OSE Reference: 25350

**Re: MCU 2024/0008 – Extractive industry at 50186 Gregory Development Road Greenvale on lot 4844 on PH1679 – Operational works application.**

**Comments on drawing submission:**

SCALE	AS SHOWN
SHEET	SHEET 3 OF 6
REVISION	A
DRG No.	1314-SMP-SK03

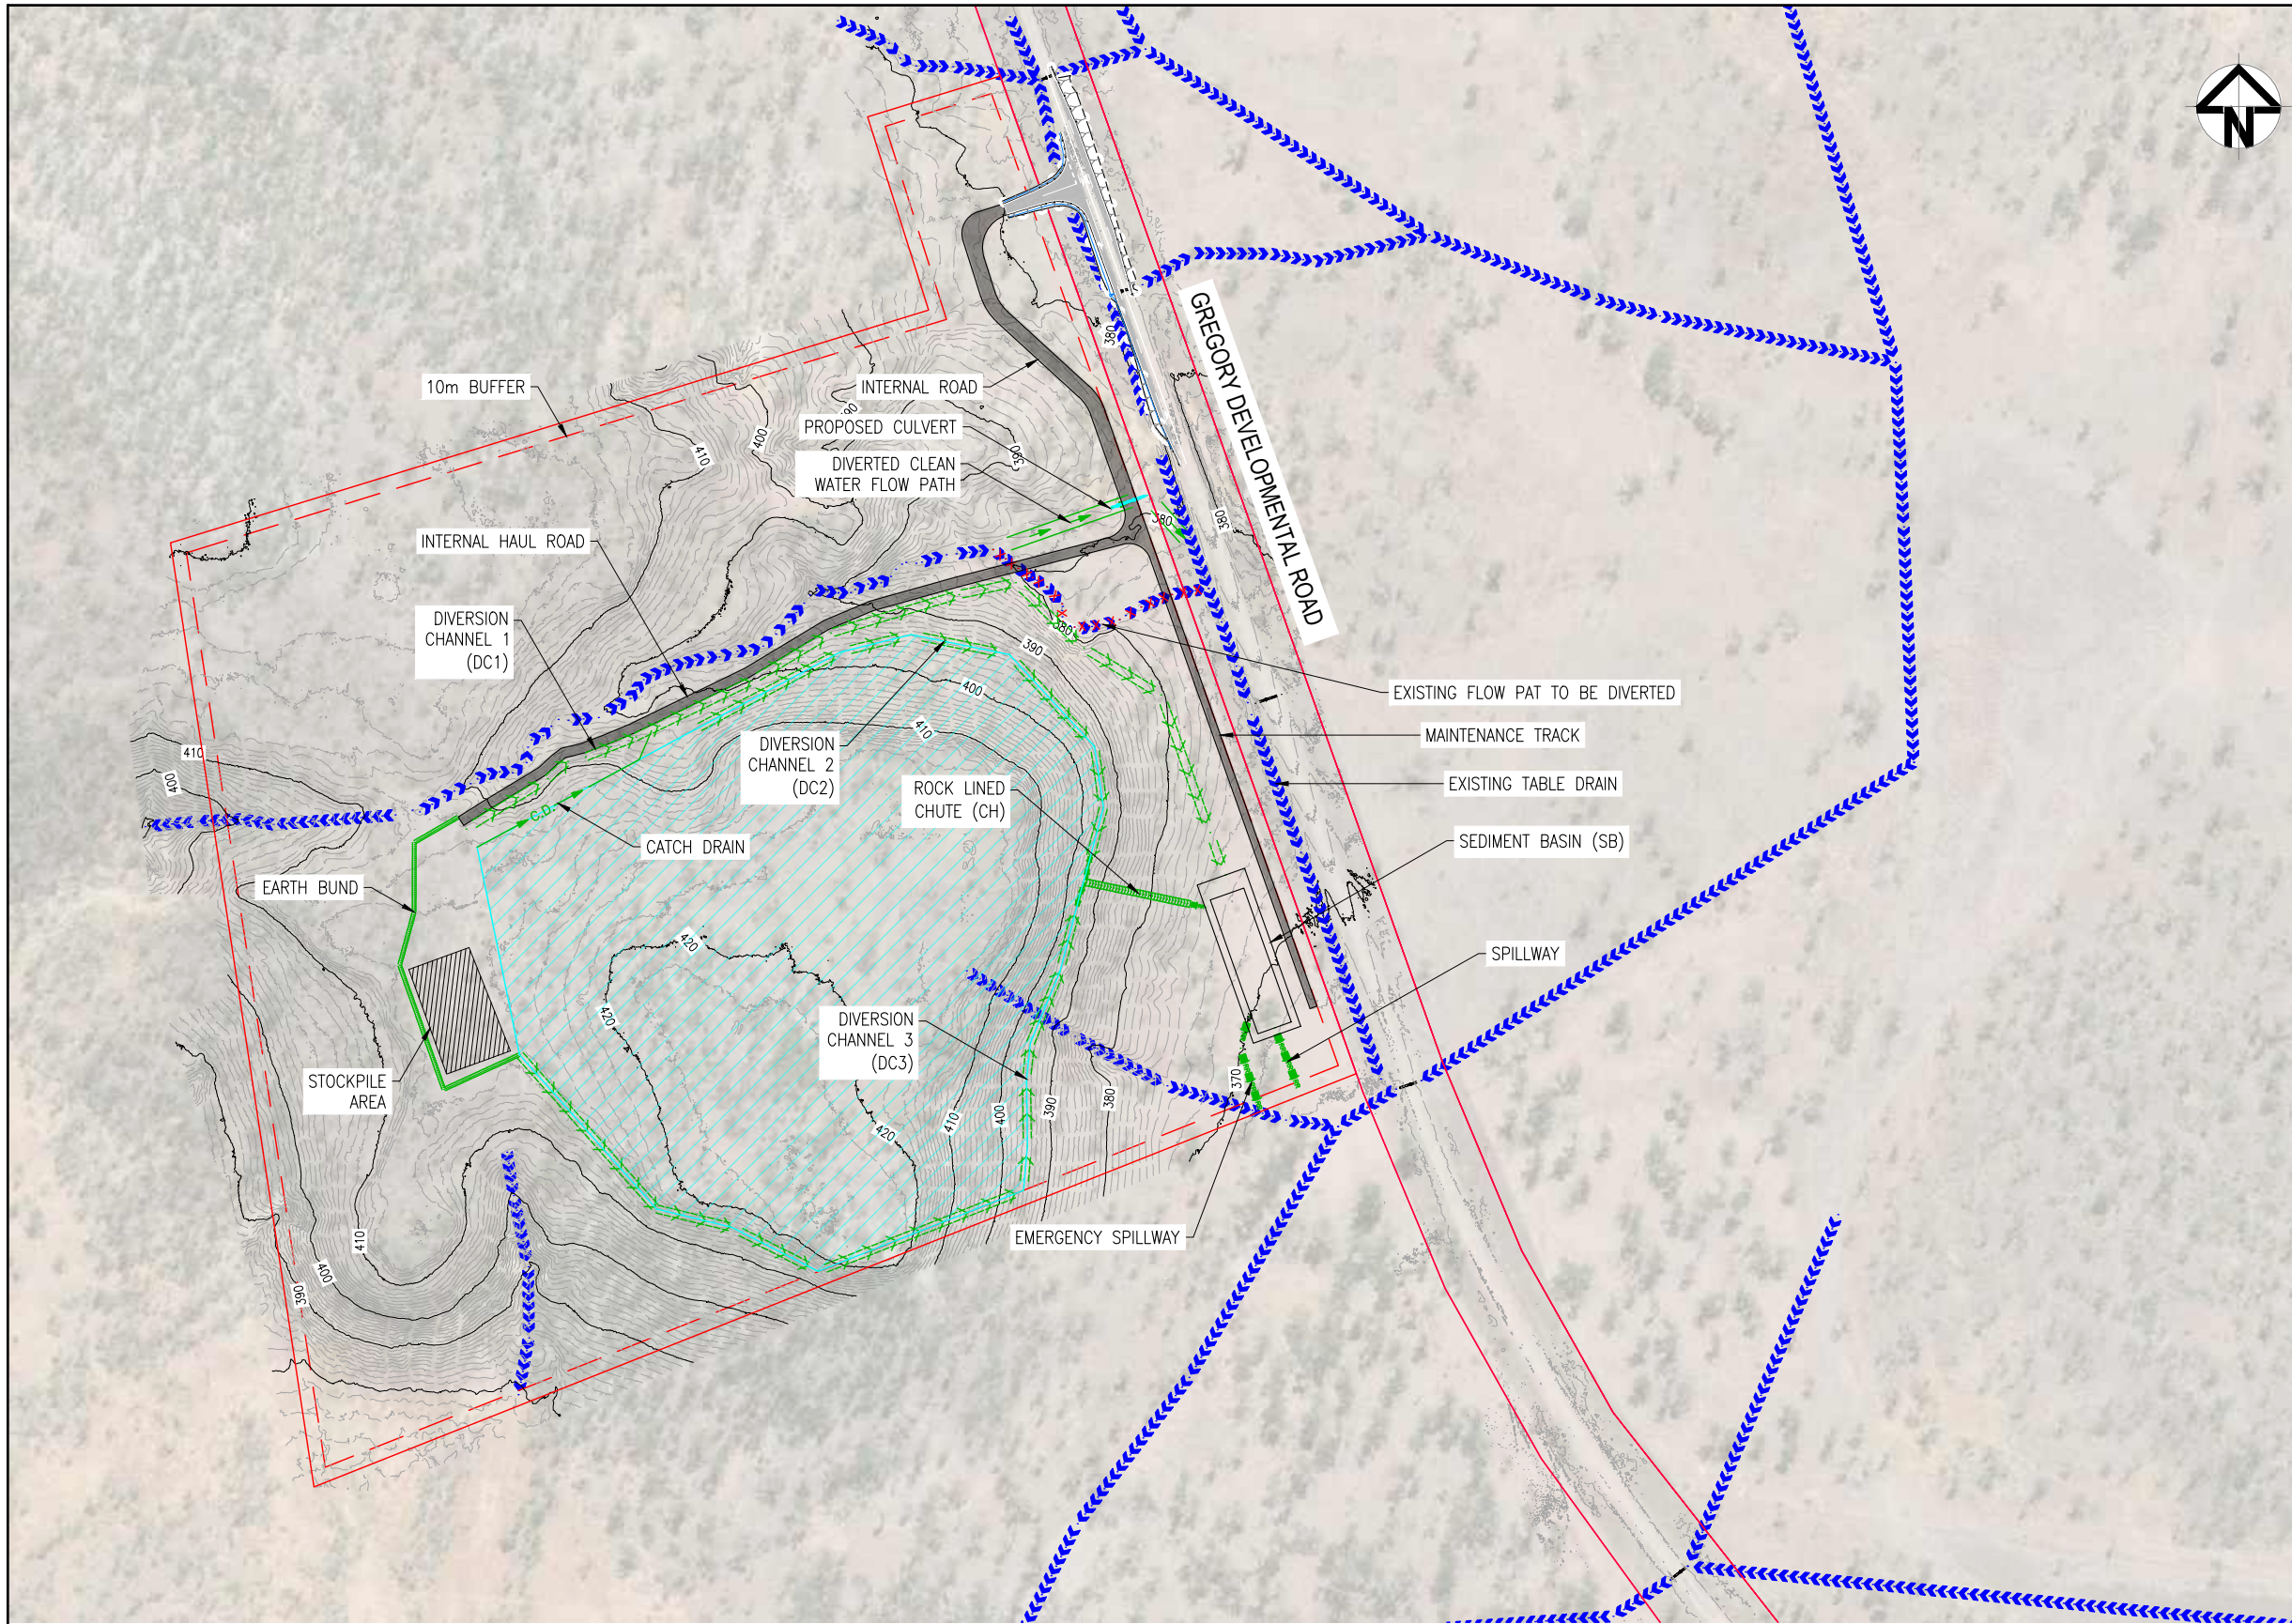
Reviewed by OSE Group and accepted

SEDIMENT BASIN BASE DIMENSIONS  
1:750 (A1)

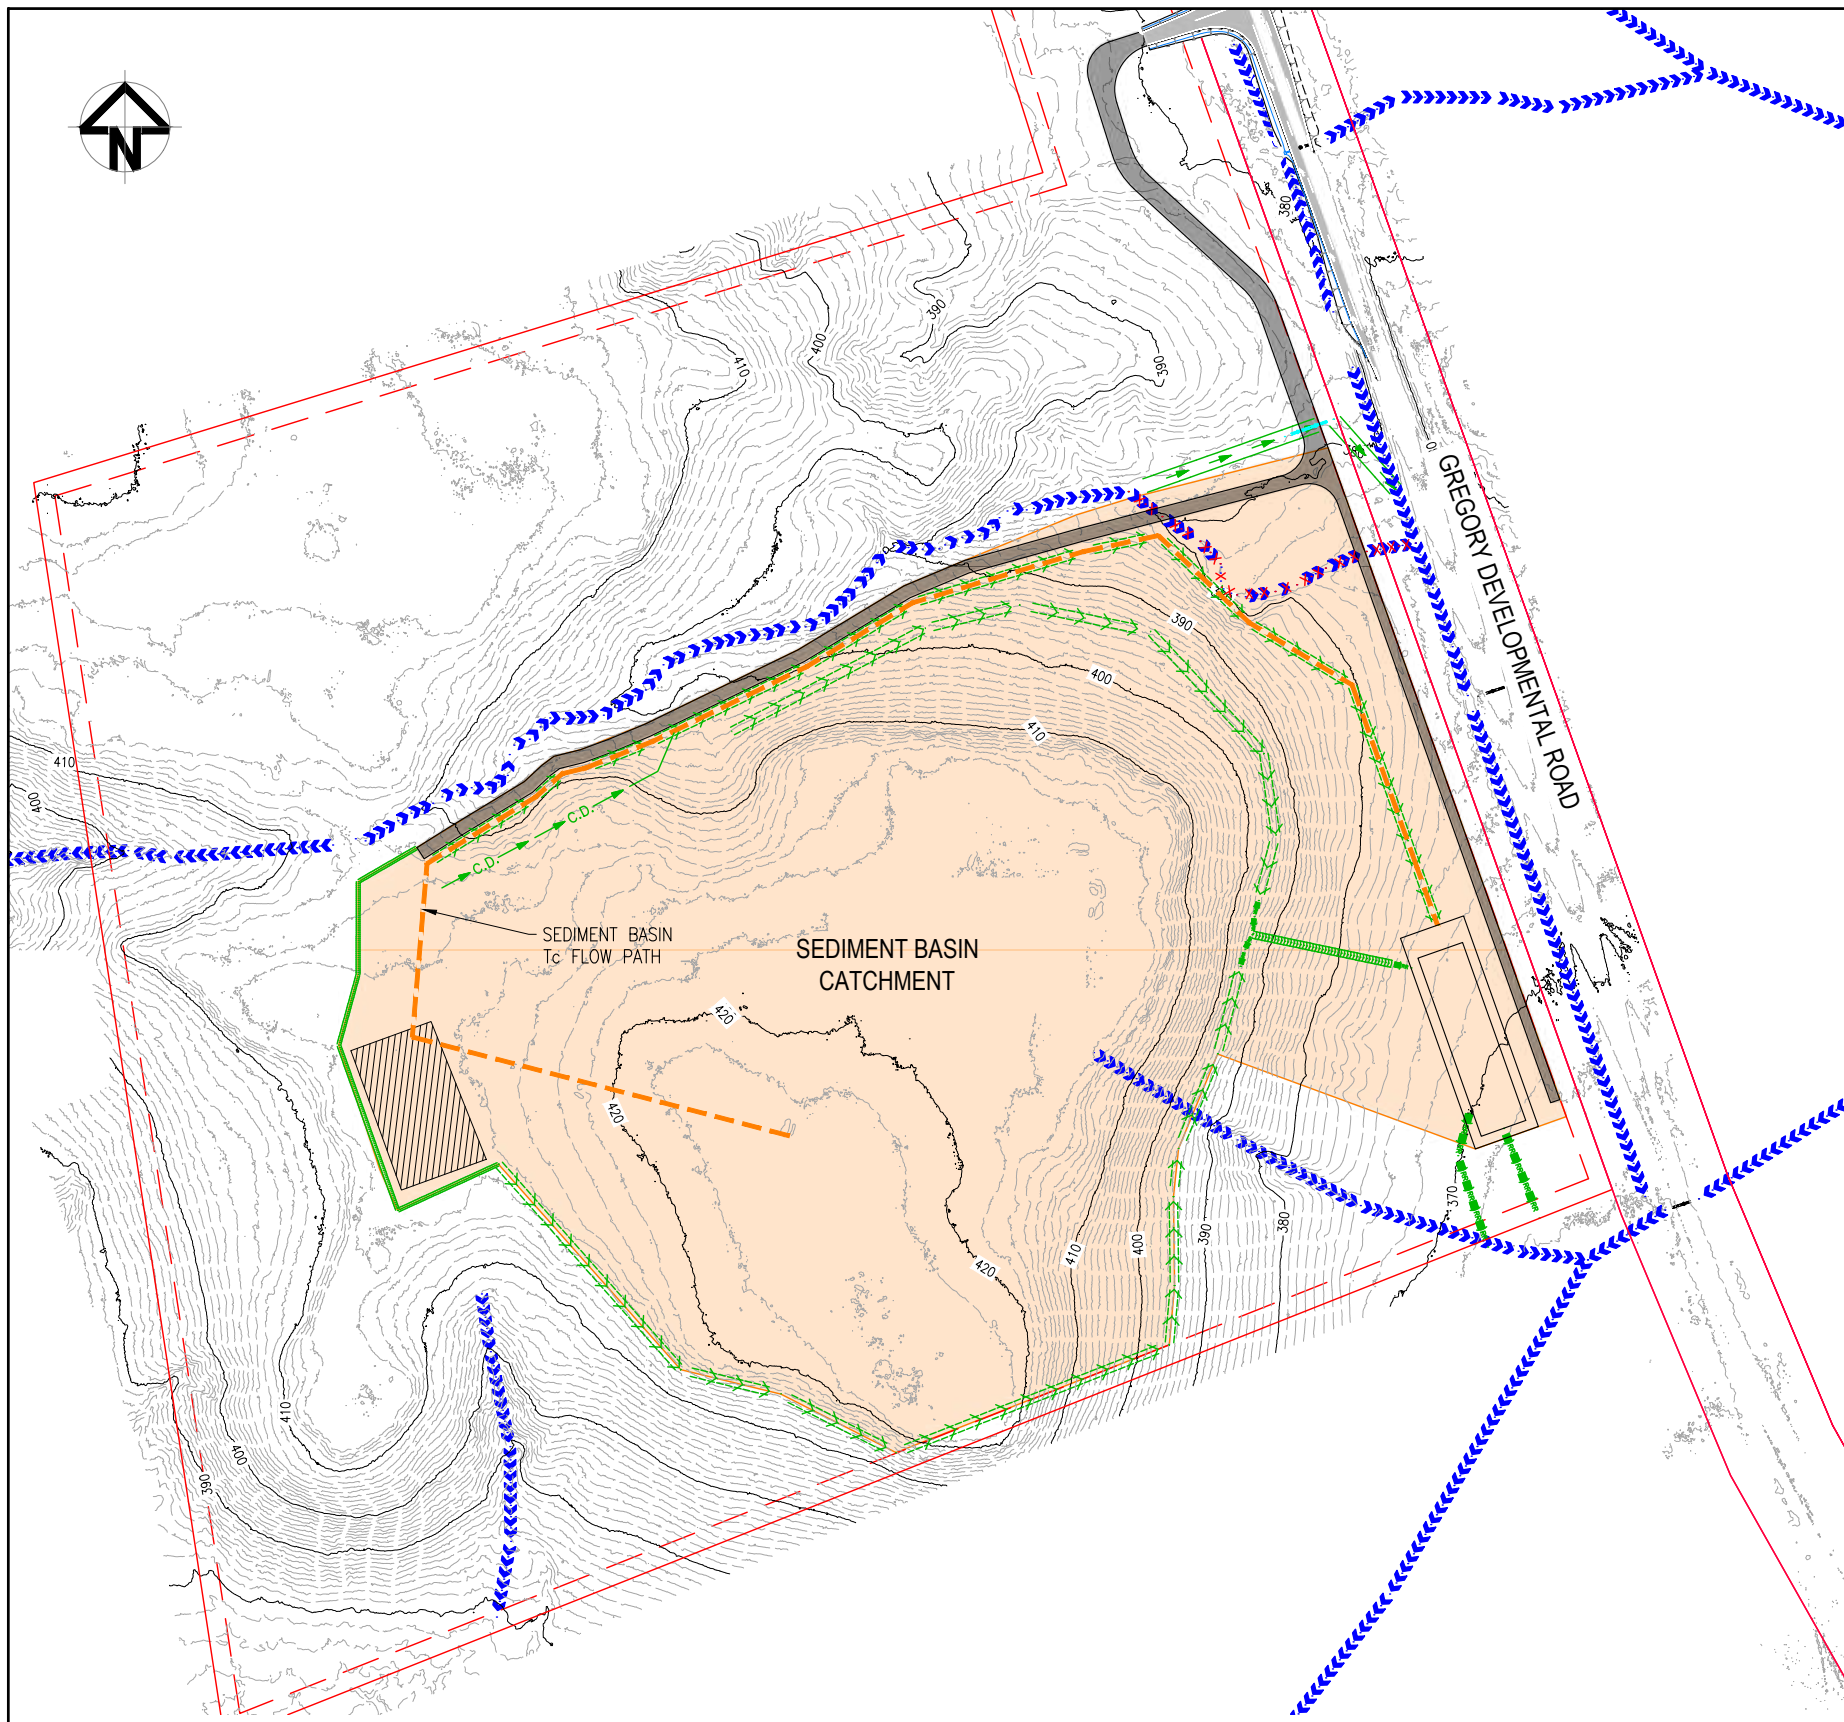
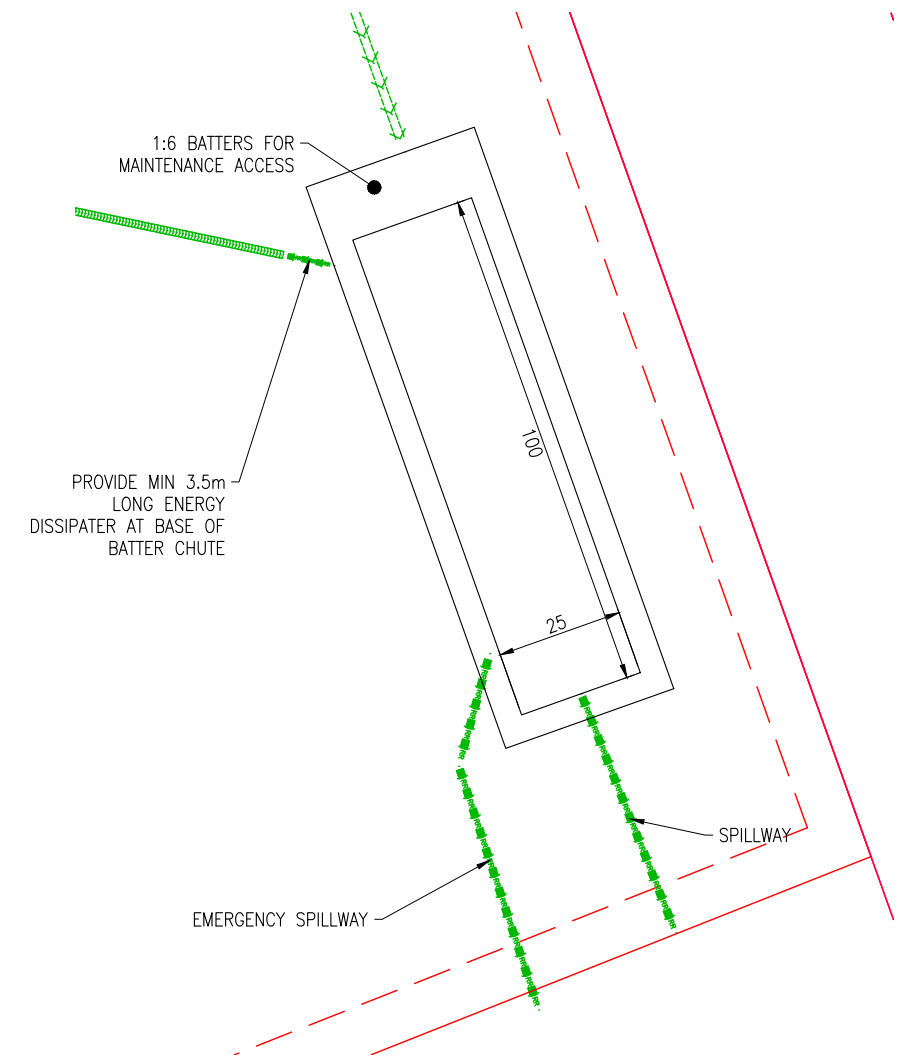
Reviewed by OSE Group - Design intent correct and accepted
